Title - Sujet Building Envelope Rehabilitation	
Solicitation No. - N° de l'invitation F1700-174255/A	Amendment No. - N° modif. 006
Client Reference No. - N° de référence du client F1700-174255	Date 2017-10-20
GETS Reference No. - N° de référence de SEAG PW-\$PWY-022-8185	
File No. - N° de dossier PWY-7-40209 (022)	CCC No./N° CCC - FMS No./N° VME
Solicitation Closes - L'invitation prend fin at - à 02:00 PM on - le 2017-10-25	Time Zone Fuseau horaire Pacific Daylight Saving Time PDT
F.O.B. - F.A.B. Plant-Usine: <input type="checkbox"/> Destination: <input checked="" type="checkbox"/> Other-Autre: <input type="checkbox"/>	
Address Enquiries to: - Adresser toutes questions à: Arthur (PWY), Carolyn	Buyer Id - Id de l'acheteur pwy022
Telephone No. - N° de téléphone (604) 364-2752 ()	FAX No. - N° de FAX (604) 775-6633
Destination - of Goods, Services, and Construction: Destination - des biens, services et construction: DFO - Kitsilano Coast Guard Station - Vancouver, BC

AMENDMENT 006

ADDENDUM 05

ADDENDUM 06

Sheet/Feuille
ASK-001R1

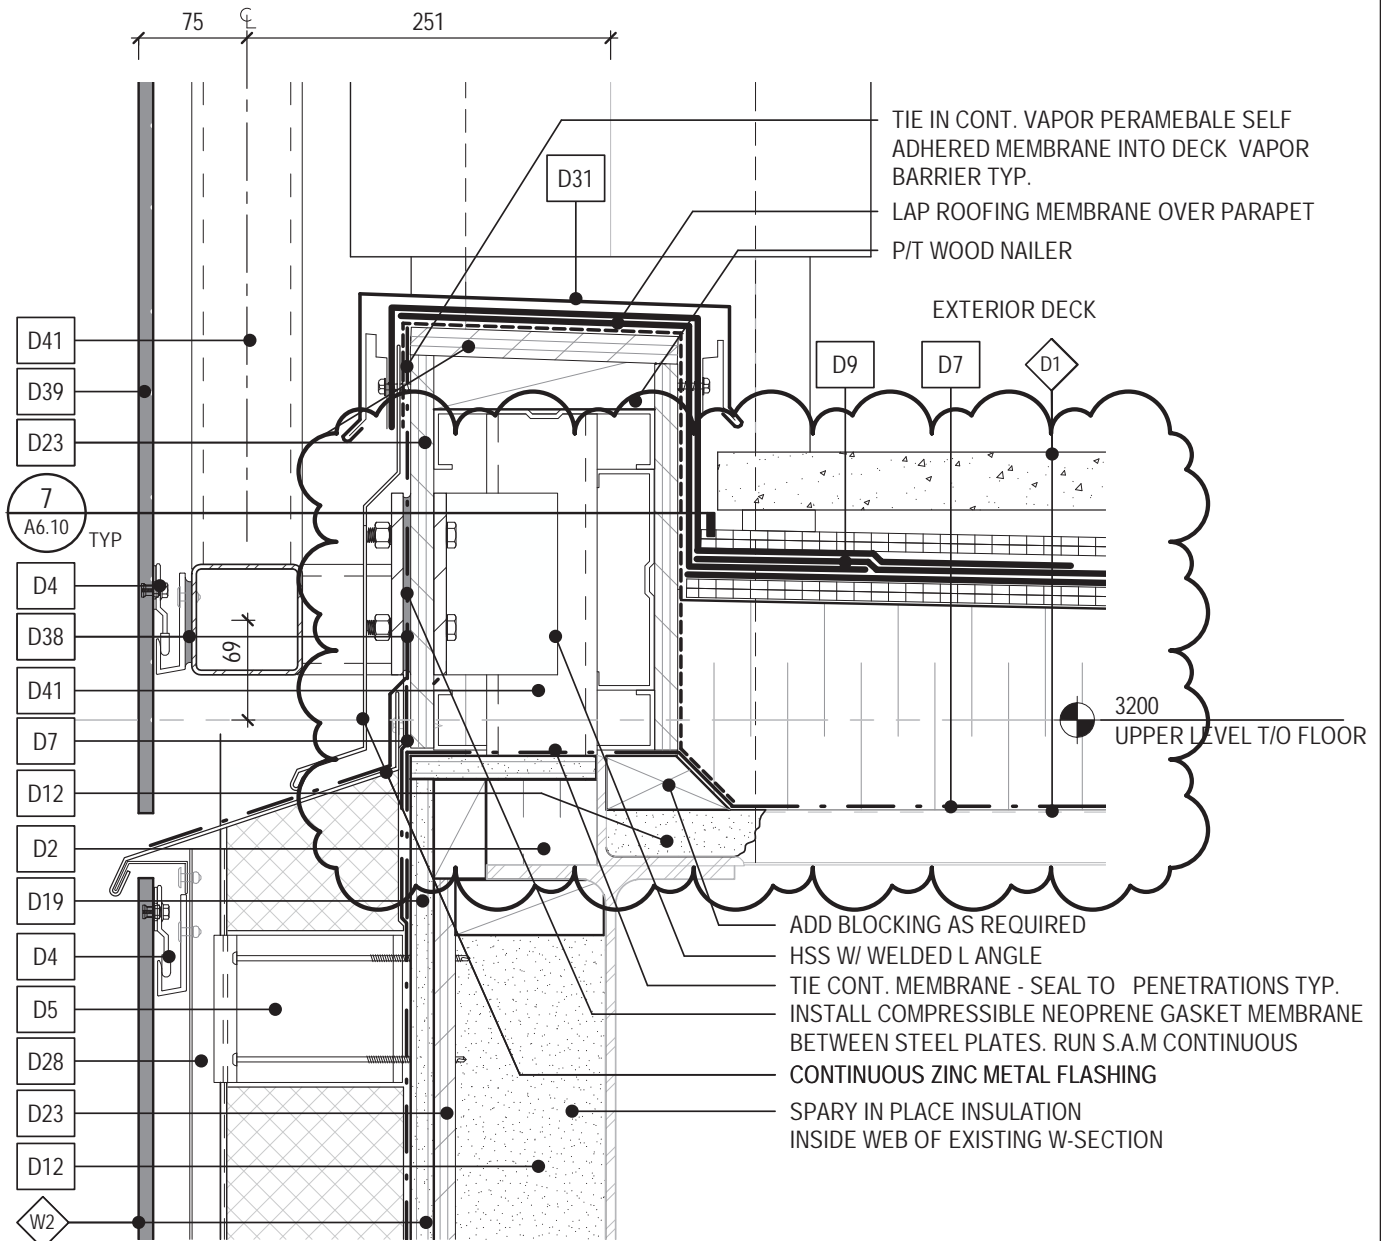
3. **Detail 2 of A6.20- Typical Guardrail transition**

Provide detail per ASK.001R1 attached.
